**NATIONAL ENERGY BOARD**

**an application by Trans Mountain Pipeline ULC  
as General Partner of Trans Mountain Pipeline L.P.  
(collectively “Trans Mountain”)  
for a Certificate of Public Convenience and Necessity and  
other related approvals pursuant to Part III of the *NEB Act***

**NPS 42 PIPELINE FROM HARGREAVES TO BLUE RIVER**

**December 1, 2014**

Figure 2.1.1 Trans Mountain Expansion Project: Revised Configuration Map

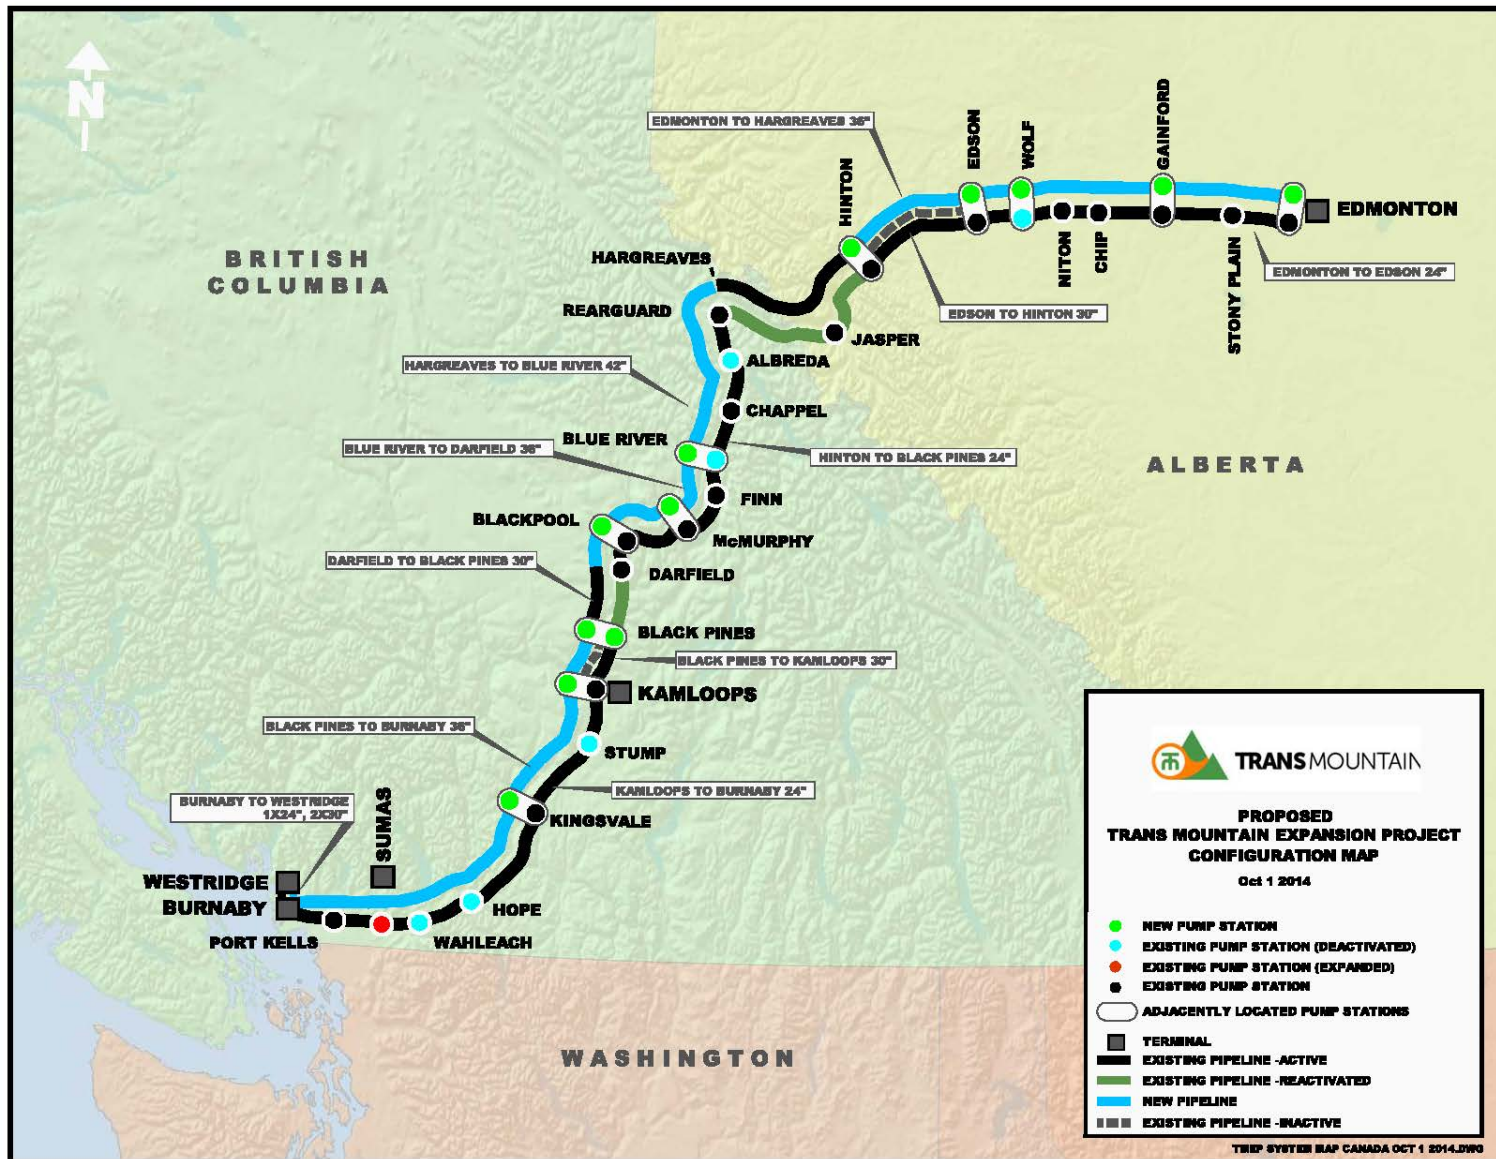
The proposed revised pipeline design has fewer environmental impacts (e.g., the avoidance of two crossings of the Fraser River associated with the previously proposed Rearguard pump station), while being more efficient (i.e., consumes less electricity). This proposed revised pipeline design, as illustrated on Figure 2.1.1, includes the following changes:

- Pipeline - increase the outside diameter of the pipeline from NPS 36 to NPS 42 (1,067 mm) for a distance of 121 km between Hargreaves, BC and the Blue River Pump Station;

- Hinton Pump Station - install one additional 5,000 HP pumping unit and three additional VFDs at the new pump station that is planned to be constructed adjacent to the existing Hinton Pump Station in Alberta;

- Hargreaves Trap Site - install a 36-inch receiving trap and a 42-inch sending trap, at the existing Hargreaves Trap Site in BC;
- Rearguard Pump Station - eliminate the new pump station and the 36-inch receiving and sending trap facility for Line 2 that was originally planned to be constructed adjacent to the existing Rearguard Pump Station. The elimination of the Rearguard Pump Station for Line 2 also results in the elimination of the 4 km of NPS 36 pipeline, including the elimination of two crossings of the Fraser River, that would have been needed to tie-in the new pump station;

- Blue River Pump Station - eliminate one of the three 5,000 HP pumping units that was planned for installation at the new pump station to be constructed at the Blue River Pump Station site. Install one VFD at the proposed pump station for Line 2 as well as a 42-inch receiving trap and a 36-inch sending trap as well as 24-inch sending and receiving traps on the existing Trans Mountain Pipeline Line (TMPL);

- McMurphy Pump Station - construct a new pump station consisting of two 5,000 HP pumping units and two VFDs, and replace the existing electrical transformer at the existing McMurphy Pump Station site; and

- Blackpool Pump Station - eliminate one of the three 5,000 HP pumping units that was originally planned to be constructed as part of the new pump station to be constructed adjacent to the existing Blackpool Pump Station. Add one VFD to the proposed pump station for Line 2 and make upgrades to the existing electrical transformer at this station.

**LOCATION OF PROPOSED  
WORK AT MCMURPHY  
PUMP STATION**

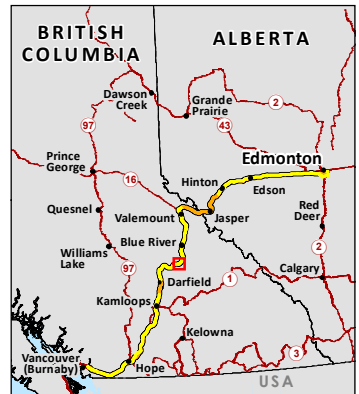
The McMurphy Pump Station was not in the scope of the Project when the Facilities Application was filed in December 2013. A summary of the environmental and socio-economic elements pertaining to the McMurphy Pump Station is provided in Table 5.2.1. The description of the environmental and socio-economic setting includes the baseline information under subject headings corresponding to those suggested in the NEB *Filing Manual* (NEB 2014). The location of the McMurphy Pump Station is shown on Figure 5.2.1.
